Document Name: ITS/BASES/TRM

<b>IPEC SITE MANAGEMENT MANUAL</b>	<b>QUALITY RELATED ADMINISTRATIVE PROCEDURE</b>	<b>IP-SMM-AD-103    Revision 0</b>
	<b>INFORMATIONAL USE</b>	<b>Page    13    of    21</b>

**Distribution of IP3 Technical Specification Amendment 220**  
(Approved by NRC December 03, 2003)

Figure 3.4.3-1:  
Heatup Limitations for Reactor Coolant System

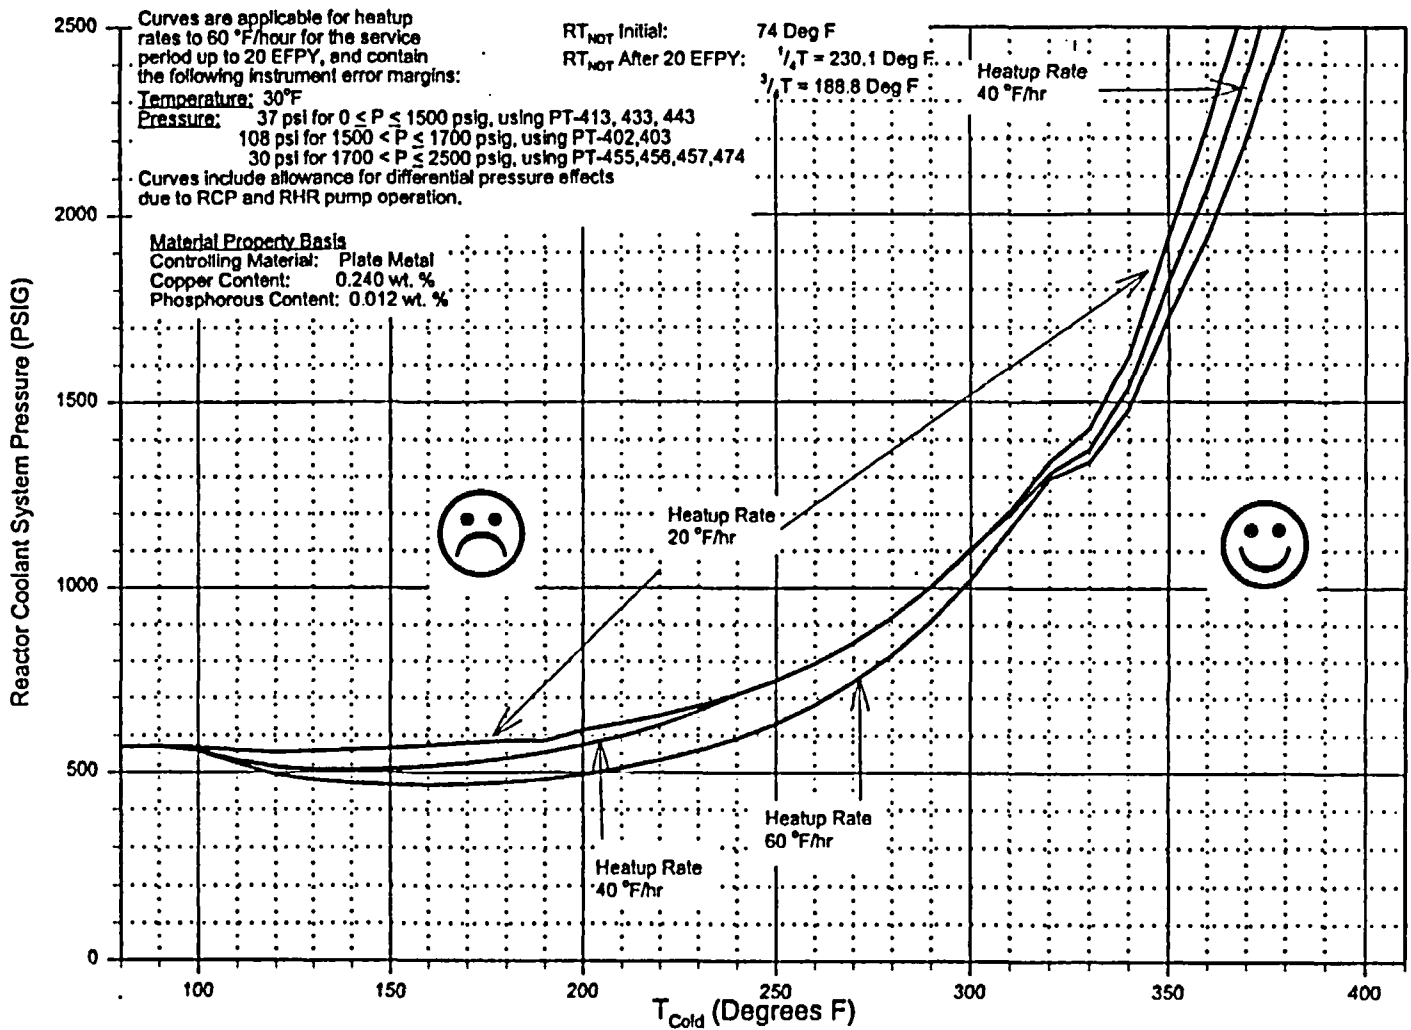
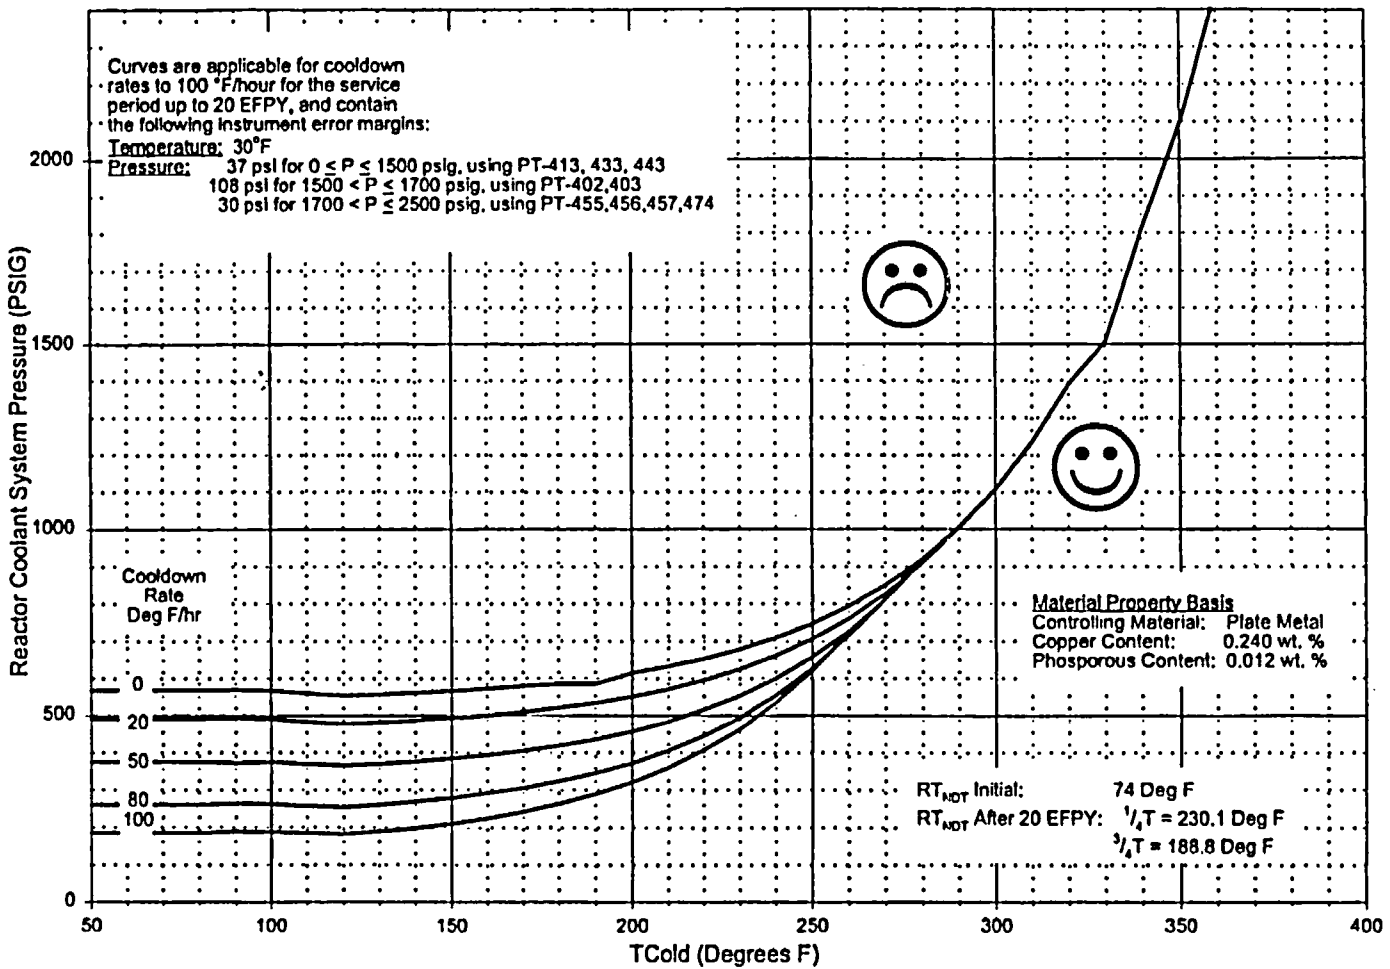
Page 3.4.3-3 (Amendment 213)

Page 3.4.3-3 (Amendment 220)

Figure 3.4.3-2:  
 Cooldown Limitations for Reactor Coolant System

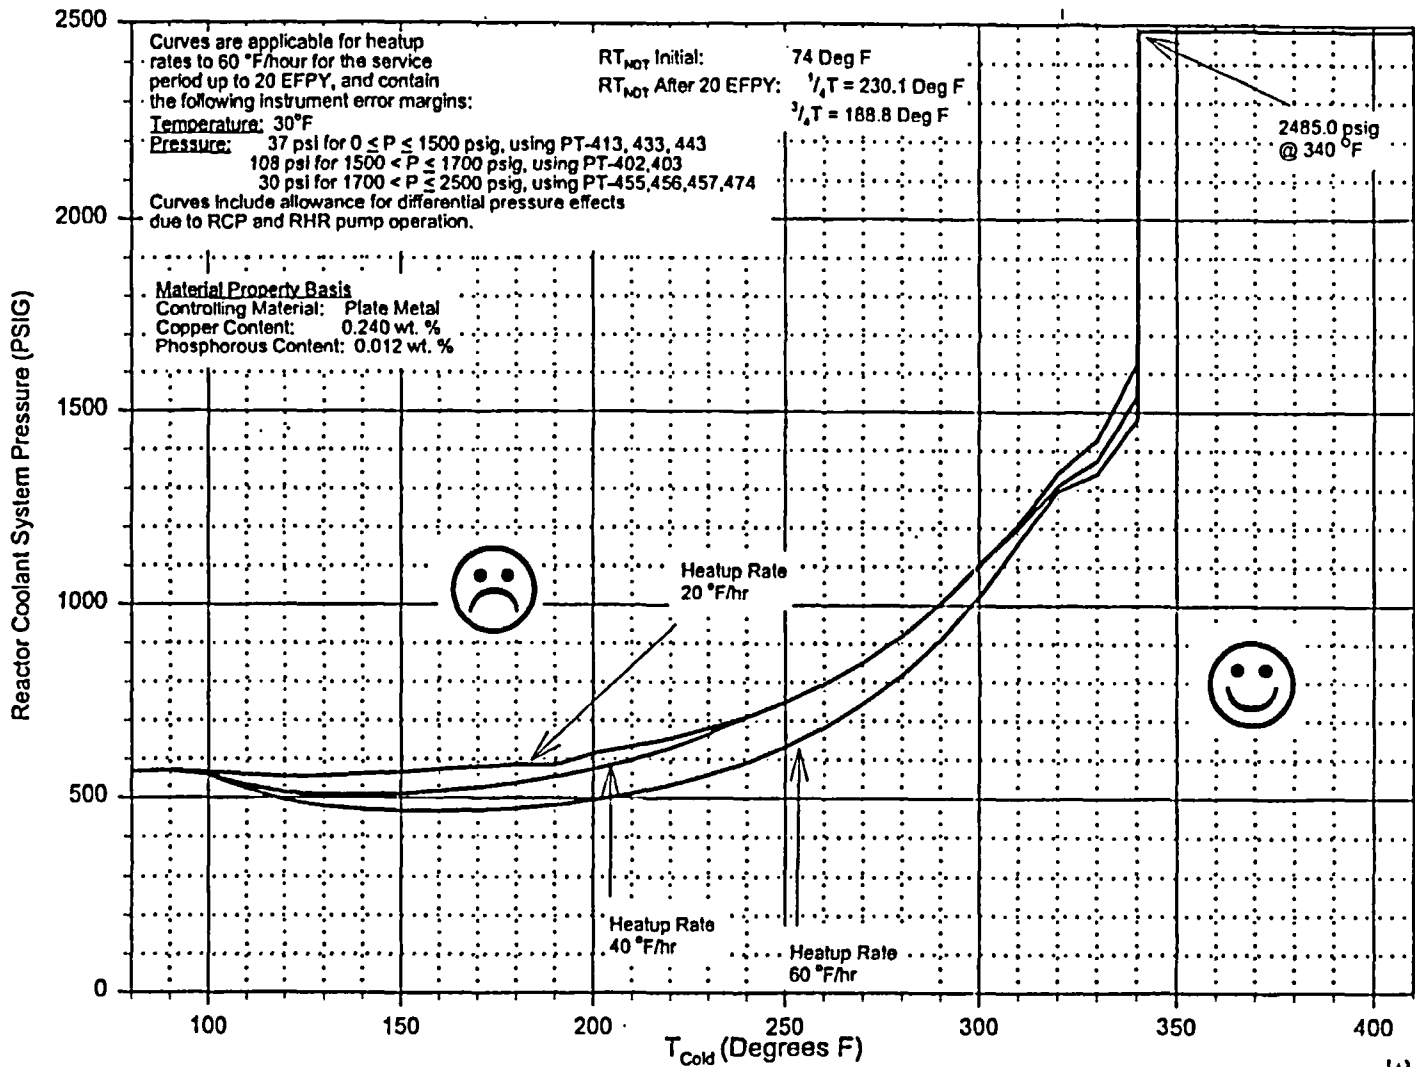
Page 3.4.3-4 (Amendment 213)

Page 3.4.3-4 (Amendment 220)

Figure 3.4.3-3:

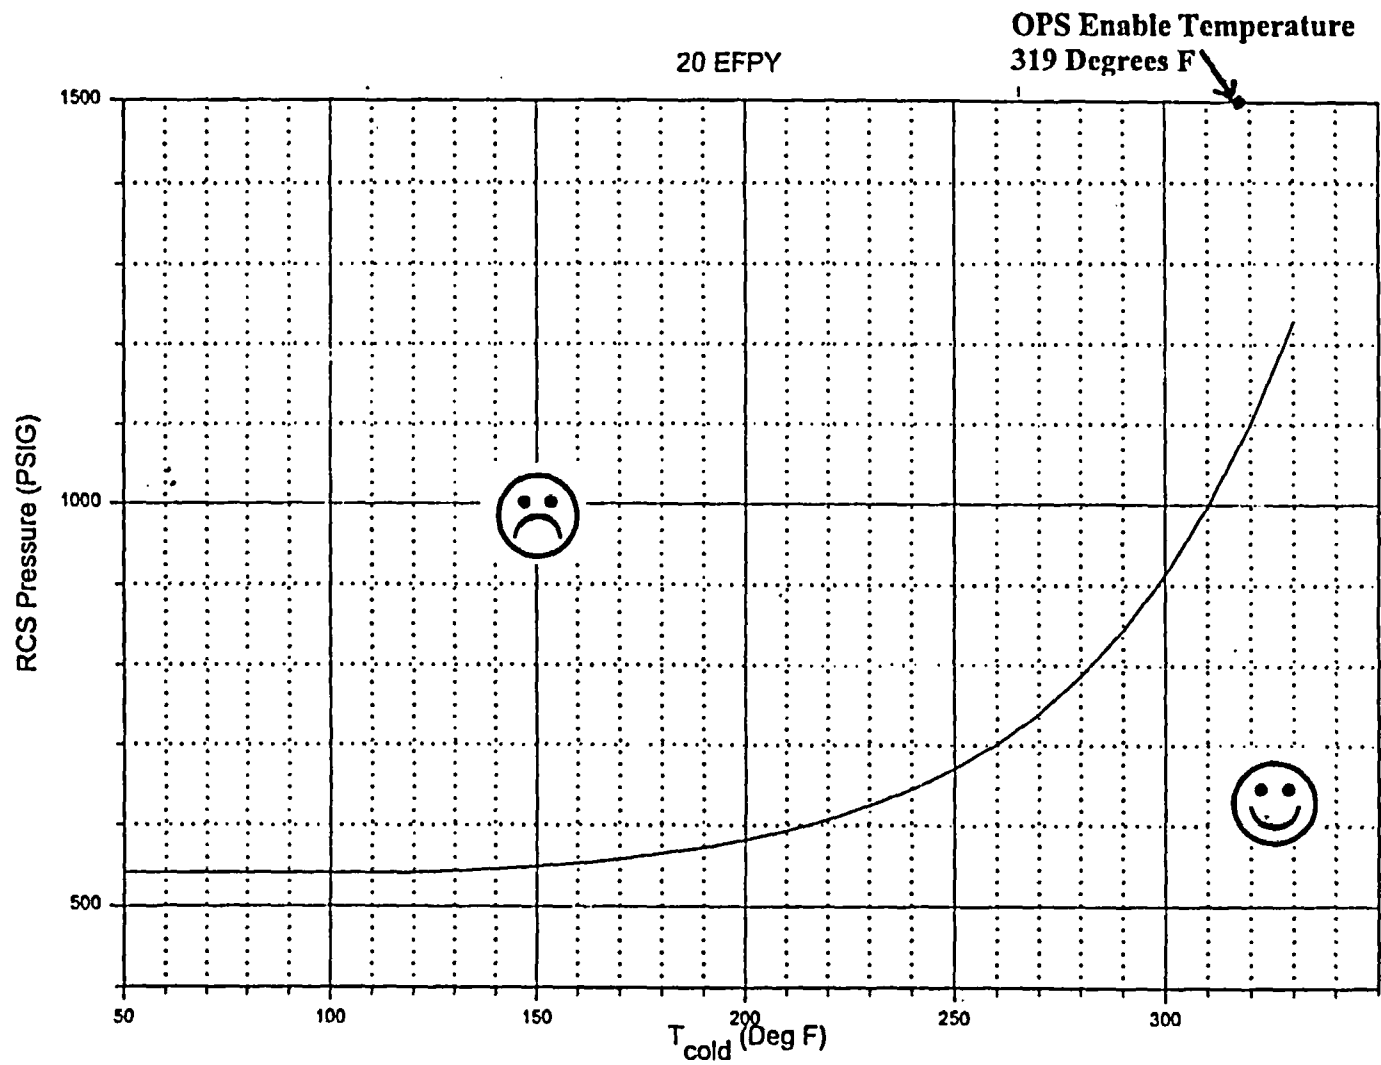
Page 3.4.3-5 (Amendment 213)

Page 3.4.3-5 (Amendment 220)
